## SUNDRY NOTICES AND REPORTS ON WELLS

**Federal 29 #5**  
**API No. 30-015-37337**

**Federal 29 5**  
**OXY USA Inc.**  
**November 12, 2011**  
**Conditions of Approval**

OXY USA Inc.  
Federal 29 #5  
API No. 30-015-37337

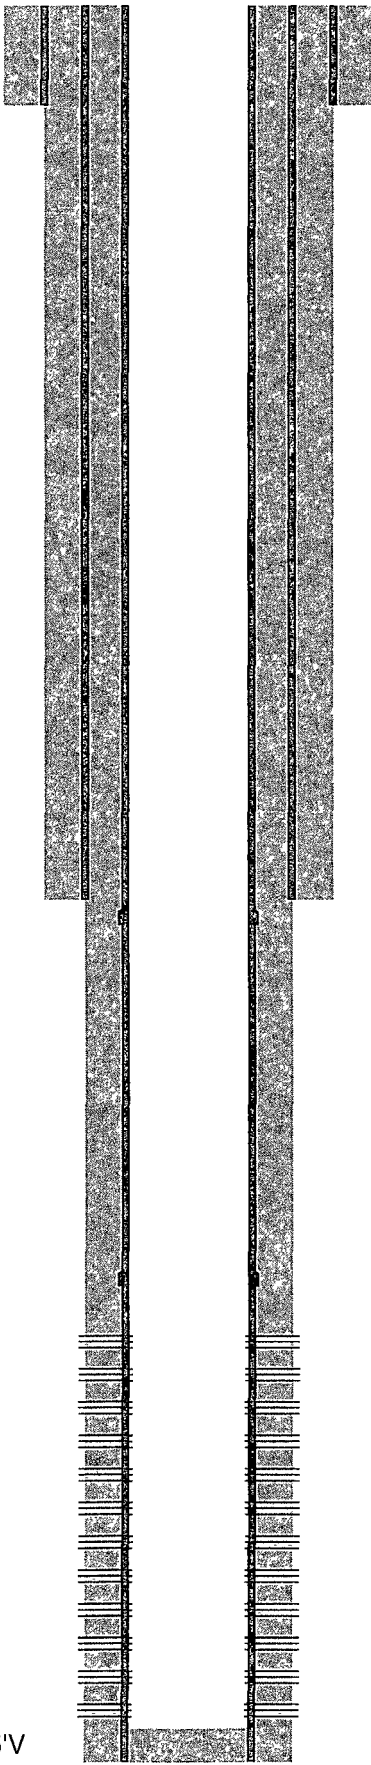
- 6. Operator limited to 3700 psi on the frac down the casing. This is based on 70% of the 5.5" 17# J-55 casing's burst rating.**
- 7. Operator to submit a subsequent sundry with details of work performed including a new well test. Due to classification as one pool under order R-10086, no completion report is required.**
